Amendment No. 0004
17 June 2003

SUBJECT: Amendment No. 0004 to Specifications and Drawings for Construction of
FLOOD PROTECTION PROJECT, VAN BIBBER CREEK, ARVADA, CO
Solicitation No. DACW45 03 B 0014.

CLOSE MESH GRATE

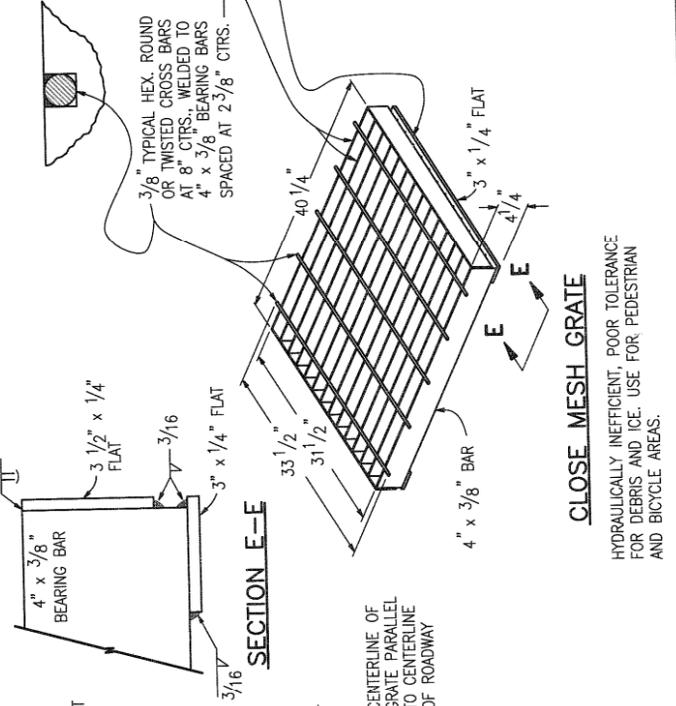
(3) Sheet C-29, (Catch Basin Details), Standard Inlet Grate Detail: Delete "Standard Inlet Grate" shown and replace with CDOT "close mesh grate" meeting requirements of CDOT standard M-604-10, Inlet Type C, or approved equal (see attachment).
